Revised Sketch Plat -
Oak Knoll Addition

Re: S/D 78-131 - Preliminary plat of Oak Knoll Addition

PROJECT NO. 30-78395-1047
 PROJECT: Oak Knoll Addition

SUBJECT S/D 78-131 - revised final plat of Oak Knoll Addition;
south side of Pawnee in an area east of
Rock Road

Item Storm Sewer Elevations @ Crossings with Proposed Continental Pipeline Relocation

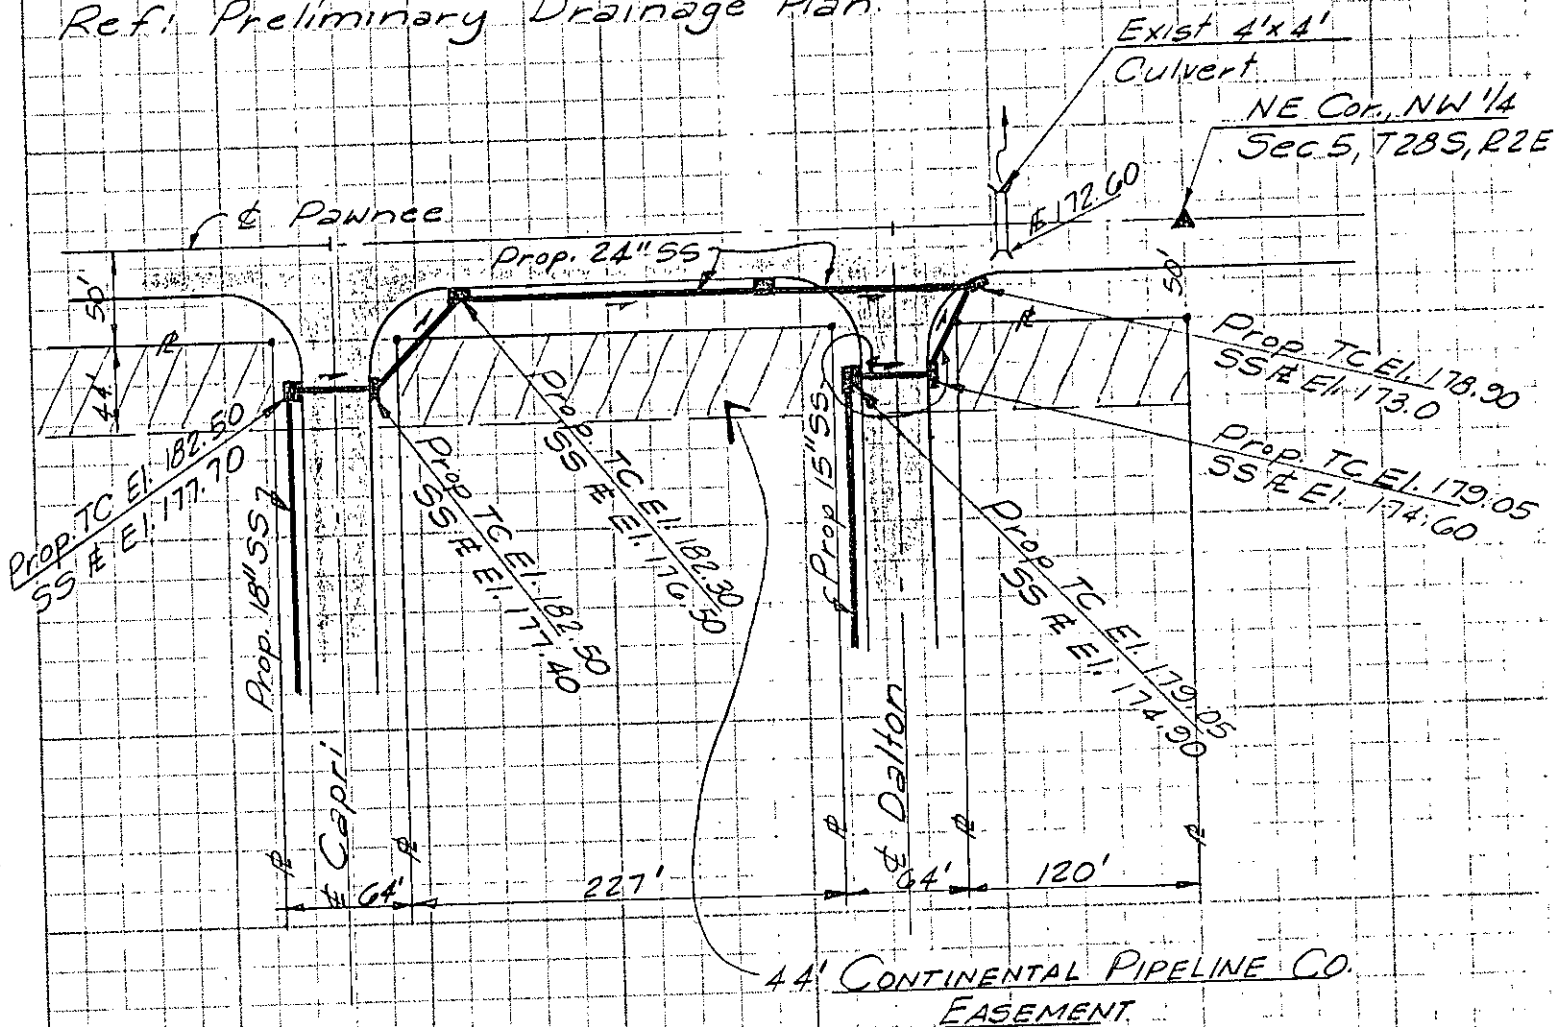
Enclosed is a sketch showing proposed storm sewer alignments and elevations where Oak Knoll Subdivision abuts Pawnee Avenue in Wichita, Kansas. This information is being furnished to assist you in developing your plans for relocating the 6" gas line.

The elevations shown are preliminary but may be considered to be within one-half foot of final plan grades. If necessary, the locations of curb inlets can be adjusted in our final plan stage to clear the relocated pipeline. Elevation is more critical at this time than precise location.
